High School in Jerrabomberra

Response to Submissions and SDRP

30.03.2022

ACCESSIBILITY VIA DAVID MADEW OVAL

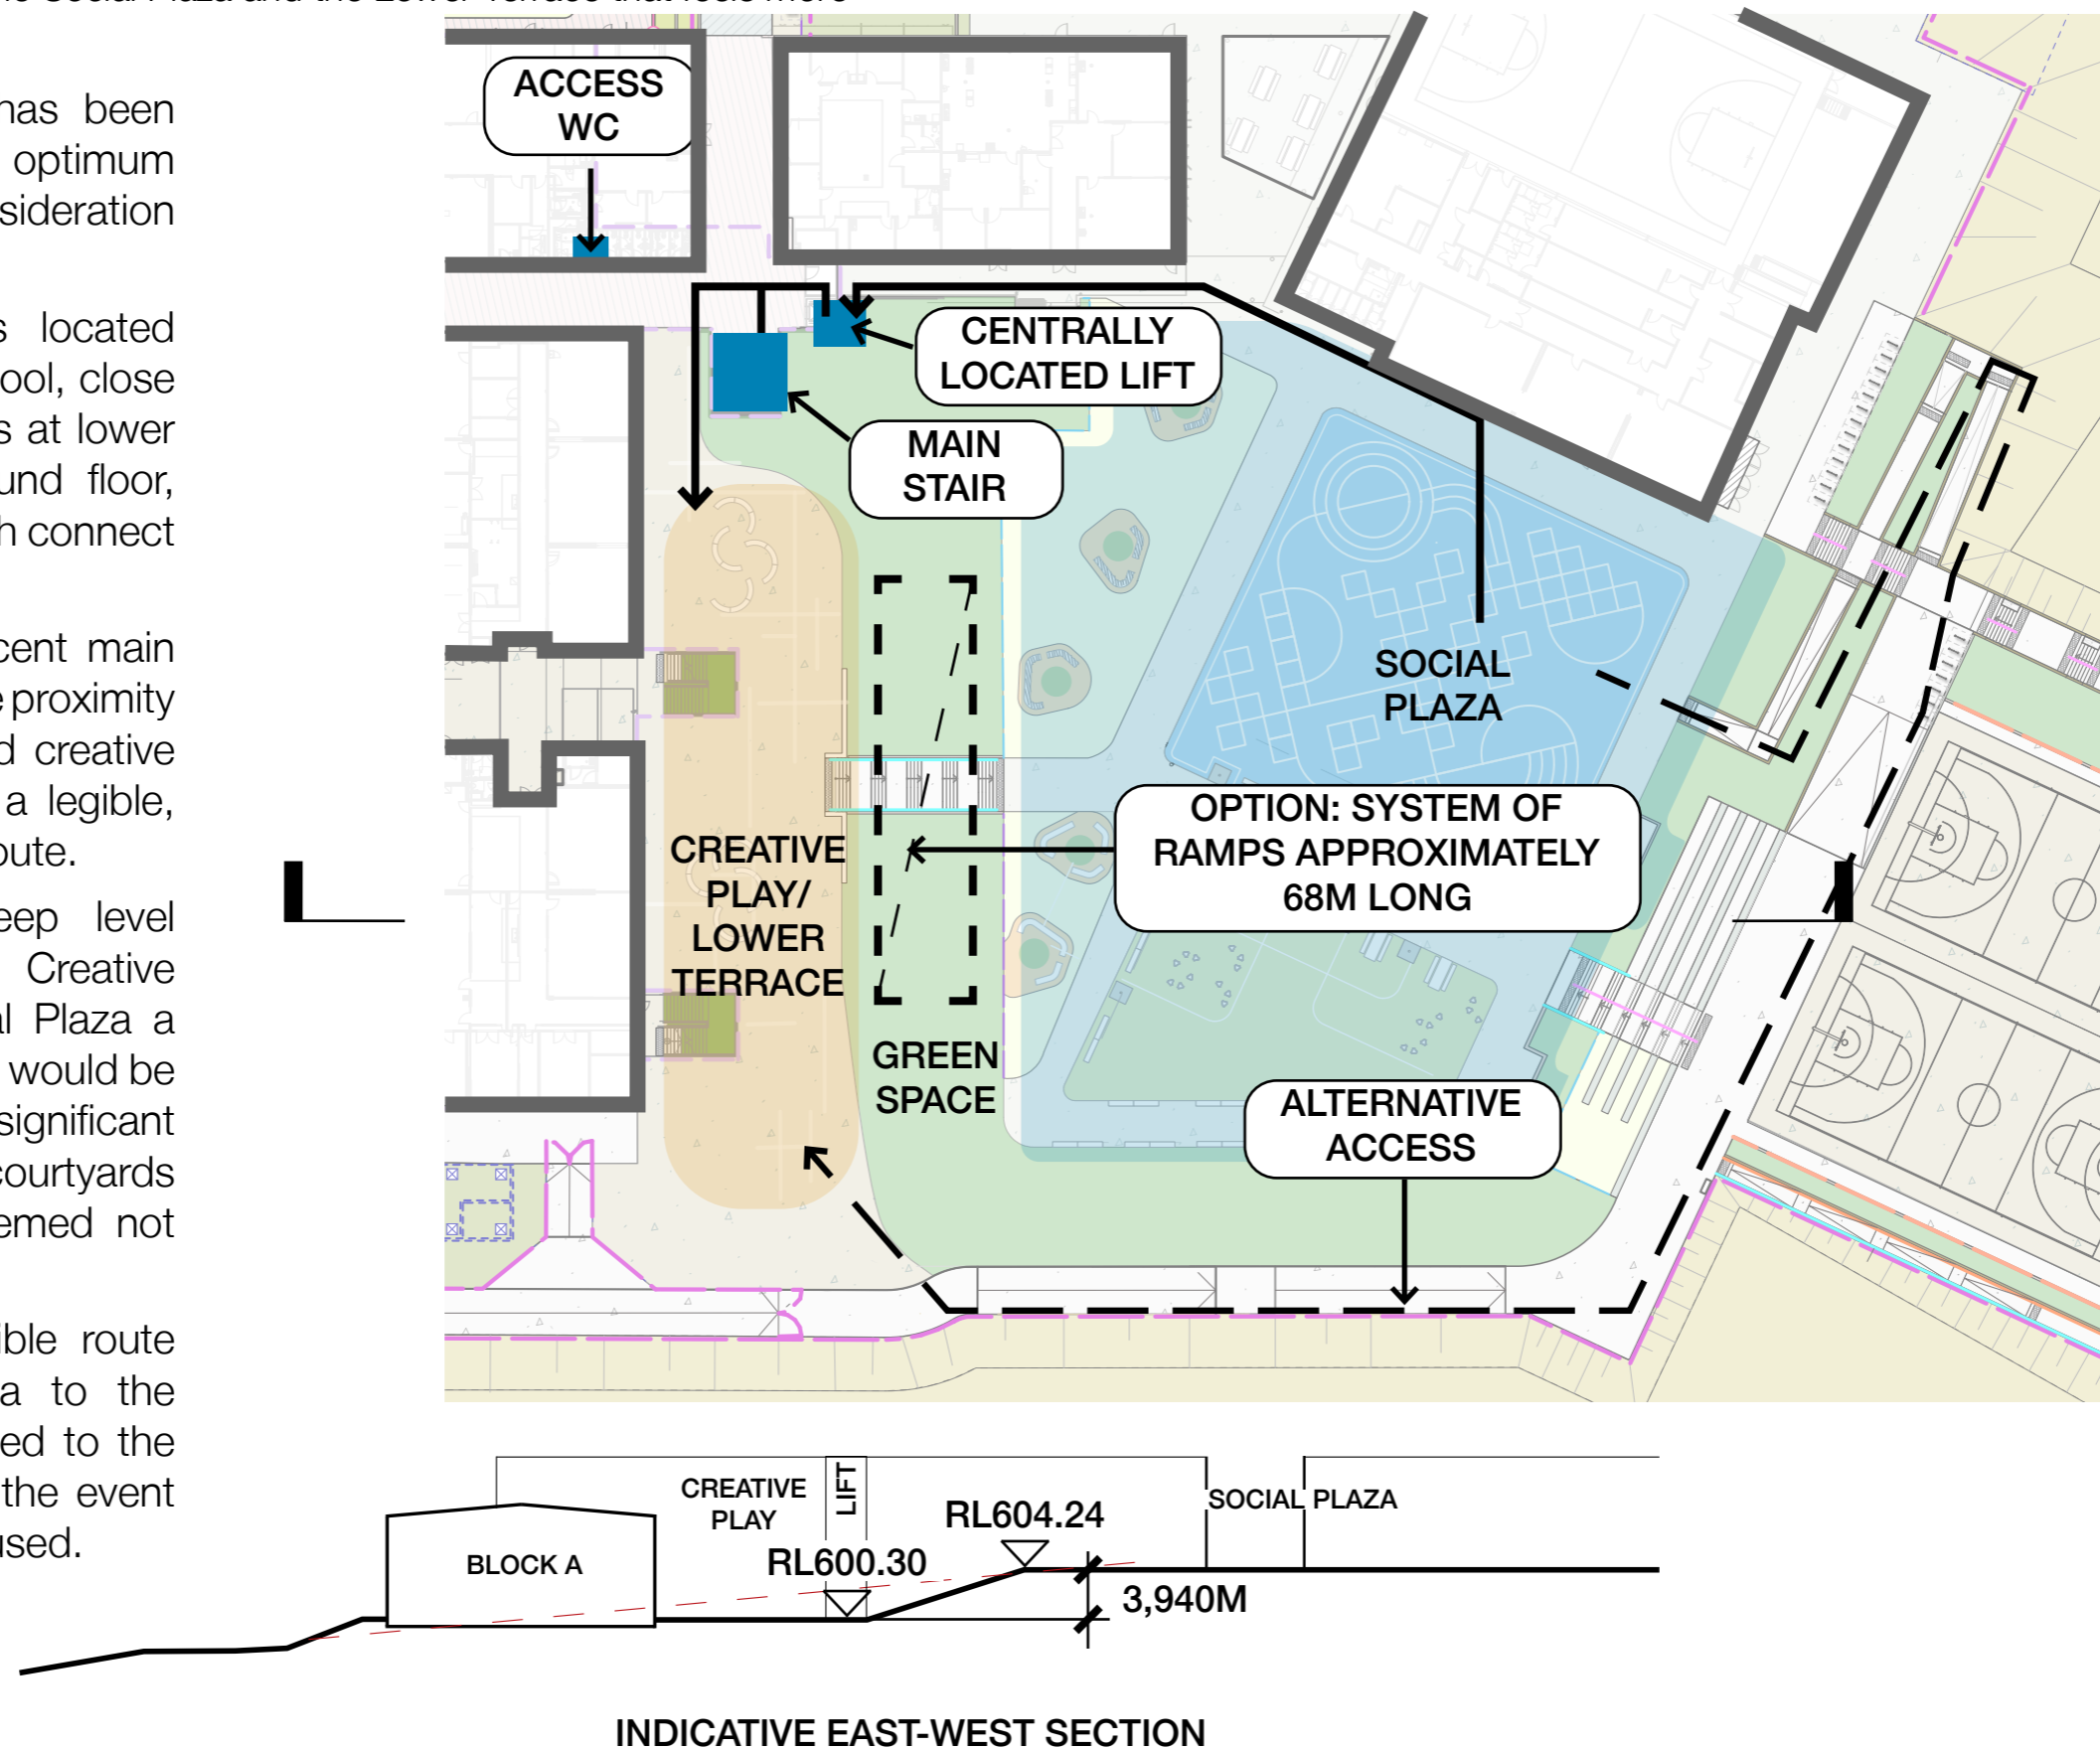
Recommendation 7c – the response does not include any options testing, and the recommendation to explore how the connection between the David Madew Oval and the school is connected and inclusive has not been adequately addressed. Options to provide an inclusive and equitable connection between the Oval and the school must be explored.

The connection to the David Madew Oval has been addressed within the constraints presented by the sloped site. A series of ramps compliant with the enhanced requirements of AS 1428.2-1992 have been provided adjacent to the steps, ensuring that all users have choice to address the level change in the way most appropriate to their needs or disability. The ramps meet the EFSG requirement to provide landings at 6m intervals (in lieu of 9m intervals as per the requirements of the BCA) to ensure the route is suitable for students or users who might tire more easily. Rest points with seating are incorporated at a convenient intervals along the ramped route, to allow an opportunity for students and staff to rest and recover, extending the ability to comfortably travel longer distances.
